**TO: PLANNING COMMISSION**

**SUBJECT: DESIGN REVIEW – CONDITIONAL USE PERMIT – SITE PLAN  
REVIEW – ADJUSTMENT – DRIVEWAY APPROACH PERMIT CASE  
NO. 20-02; 5611 WOODSIDE DRIVE SE - 97306  
AMANDA NOS. 20-102371-DR, 20-102369-ZO, 20-102373-RP, 20-  
102375-ZO, 20-108782-ZO**

Summary: An application to develop an 18-unit multiple family residential development, with associated site improvements.

CHARLENE'S HOUSE  
APARTMENTS

## PRELIMINARY SITE PLAN

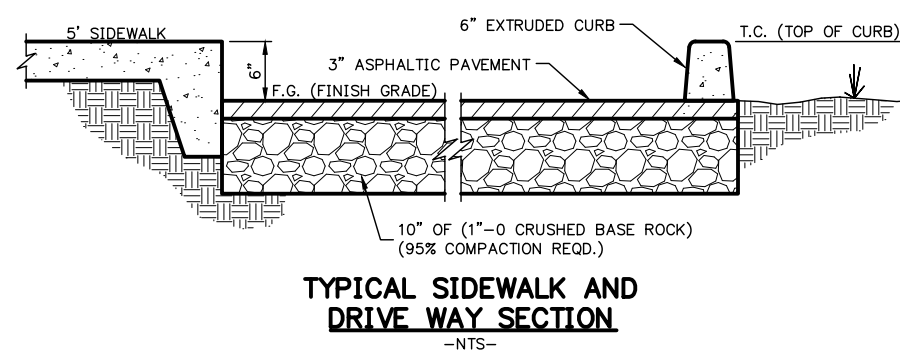
**Finding:** The existing conditions plan provided by the applicant indicates that there are 13 existing trees on the subject property, with no significant trees (Oregon white oaks greater than 24 inches in diameter at breast height). The plans and written statement provide different information in terms of which trees are proposed for removal and conservation. The proposed site plan shows 4 trees marked for removal, and 9 trees marked for preservation; while the site plan and written statement state that all trees on the site may be removed during development. Additionally, the site plan and written statement misstate that there are 19 trees on the subject property. A previous permit involving the subject property allowed the removal of 4 of the 13 trees, leaving 9 trees marked for preservation as shown on the applicant's site plan; these numbers were confirmed by City staff who visited the subject property. These 9 trees are located within the perimeter setbacks and should be preserved to the maximum extent feasible.

**Finding:** The proposed site plan includes a pedestrian network that connects each portion of the development. The proposed off-street parking area is relatively narrow in width (approximately 82 feet), with a paved pedestrian pathway connecting the two sides of the development on the north side of the parking area and the existing public sidewalk providing a connection between the two sides of the development to the south of the off-street parking area.

**Condition 7:** At the time of building permit application, revise the off-street parking area to meet the 15-foot minimum setback to the north property line for the vehicle use area; or adjust this standard through a land use action.

**Condition 1:** The nine trees identified on the proposed site plan for preservation shall be marked and protected during construction, or in the case of any tree removal, two new trees shall be planted for each tree removed. Replanted trees shall be of either a shade or evergreen variety with a minimum 1.5-inch caliper. Any significant tree shall require that at least 70 percent of a circular area beneath the tree measuring one foot in radius for every one inch of dbh be protected by an above ground silt fence, or its equivalent. Protection measures shall continue until the issuance of certificate of final occupancy for the proposed development.

**Condition 3:** On both sides of the proposed driveway approach, provide a minimum of one tree as well as a 30-inch-tall brick, stone, or finished concrete wall to buffer the off-street parking area from Mildred Lane SE. The setback areas shall be landscaped according to the Type A standard set forth in Salem Revised Code Chapter 807. Any portion of the wall that encroaches into a vision clearance area set forth in Salem Revised Code Chapter 805 shall have a height no greater than the maximum allowed under Salem Revised Code 805.010.

**Condition 7:** At the time of building permit application, revise the off-street parking area to meet the 15-foot minimum setback to the north property line for the vehicle use area; or adjust this standard through a land use action.

SOUTH ELEVATION (TYPE A UNITS)  
SCALE: 1/8" = 1'-0"  
BLD. 1

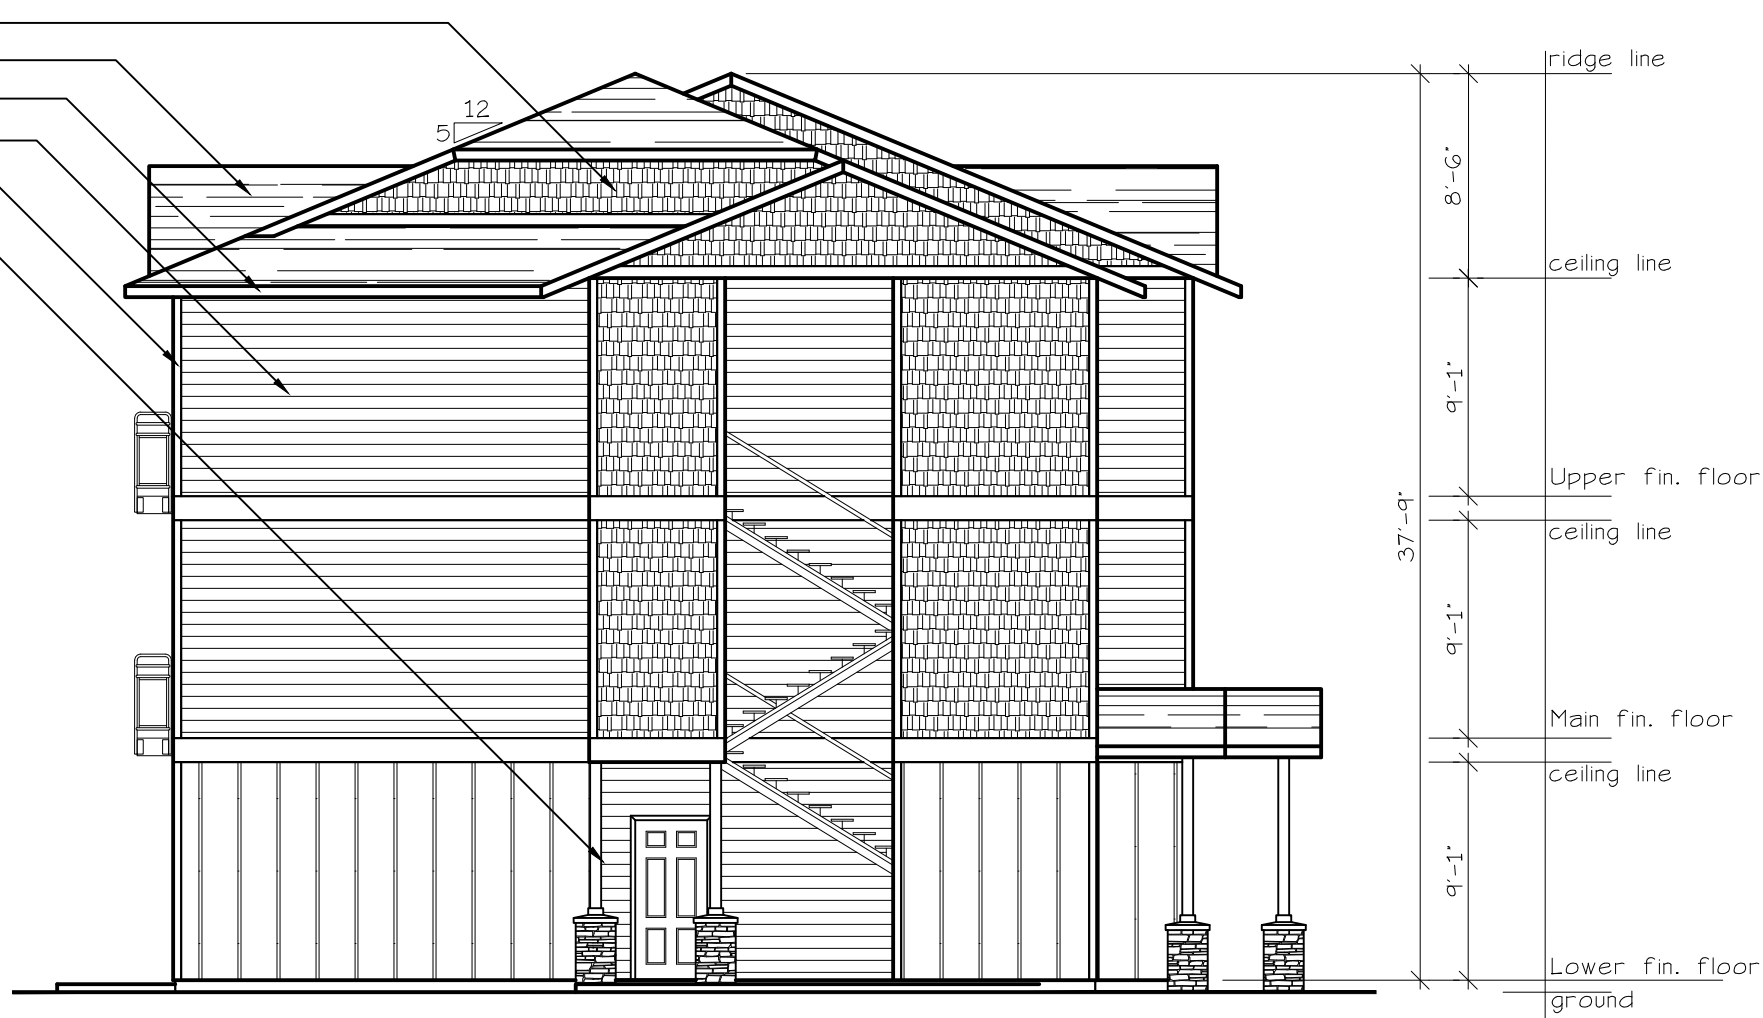
**Finding:** The design standards require windows to be provided in all habitable rooms, other than bathrooms, that face required setbacks, common open areas, and parking areas. The proposed plans indicate that windows will be provided in all habitable spaces which face towards open space and parking areas. The south elevation for Building 1 does not show any windows dispersed throughout the façade. To ensure the intent of this design guideline is met, Staff recommends the following condition of approval:

**Condition 4:** Provide a minimum of one window per floor on the south façade of Building 1.
